Armed Forces Radiobiology Research Institute

AFRRI R-84 Annual Report  
October 1980

## REPLACEMENT OF THE AFRRI-TRIGA REACTOR TRANSIENT ROD

Transient Rod  
Figure 1

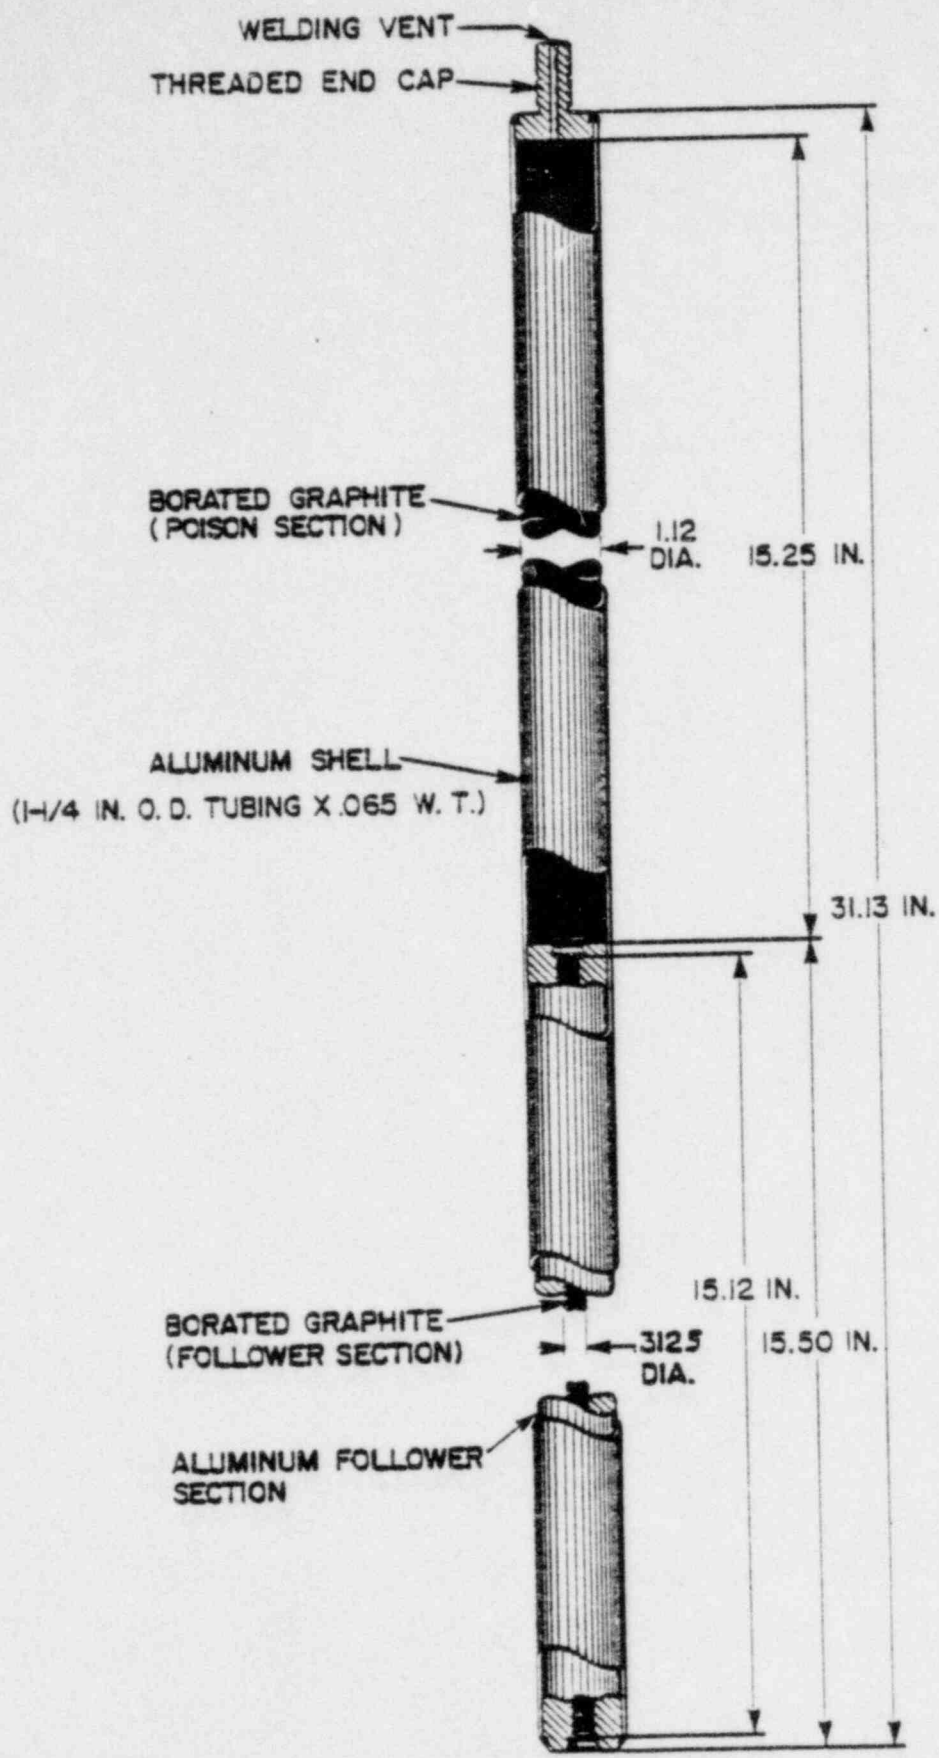
The only difference in a poison followed control rod and an aluminum followed control rod is the addition of a 5/16" diameter core of poison material in the core of the aluminum cylinder that comprises the lower section of the rod (see Figure 1).

Transient Rod Drive Mechanism

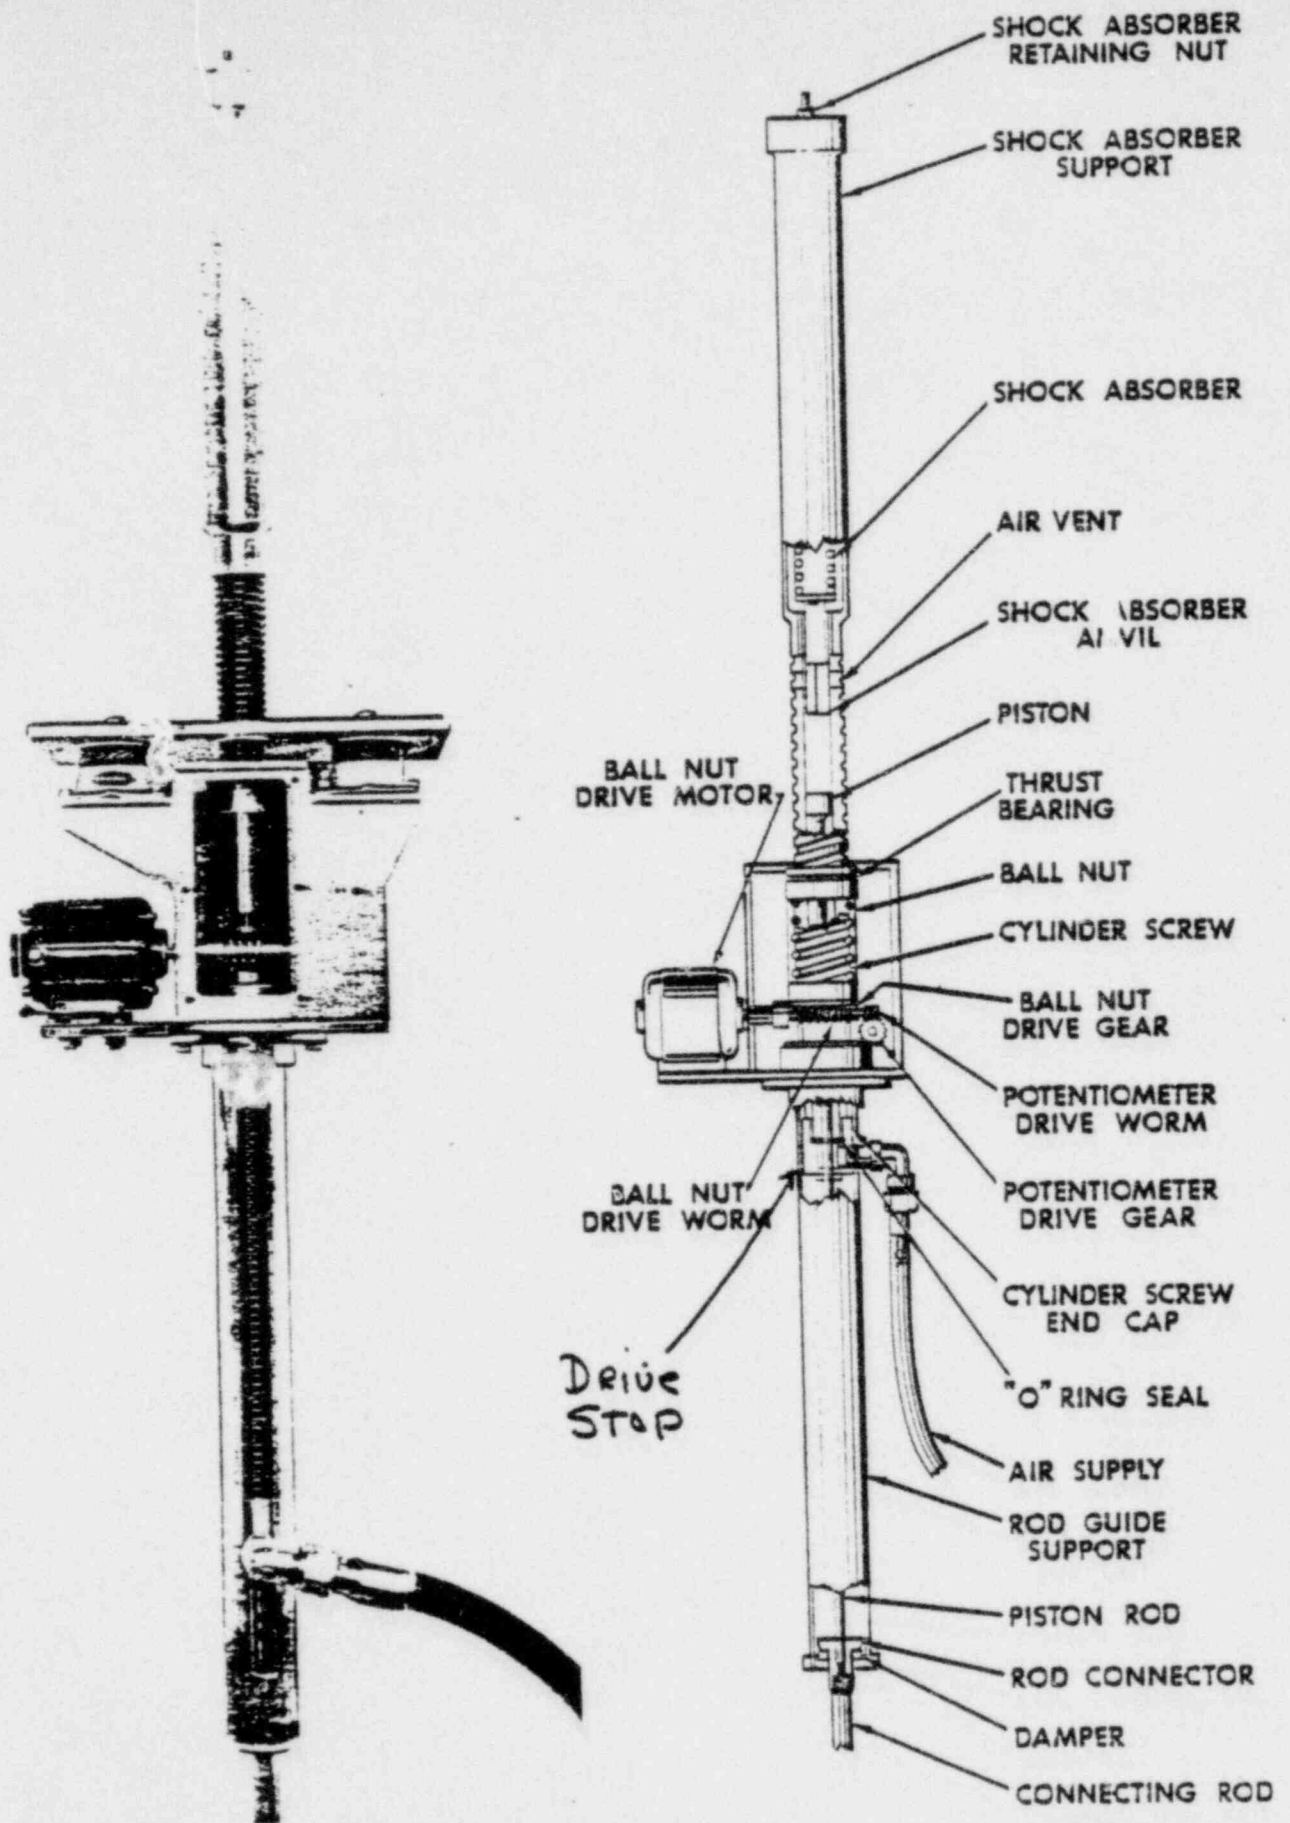
The technical specifications contained in AFRRRI License R-84 states (Section II, part A-2) "The maximum step insertion of reactivity shall be \$3.28 (2.3% delta K/K) in the pulse mode." With a transient rod worth \$4.09, it would be possible for an operator to inadvertently insert reactivity above that in the specification. To prevent such an occurrence, a physical stop has been placed on the transient drive such that the limit of \$3.28 cannot be exceeded. This is accomplished by stopping the rod drive at approximately 11 inches of travel rather than the full 15 inches previously available (See Figure 2 for stop location).
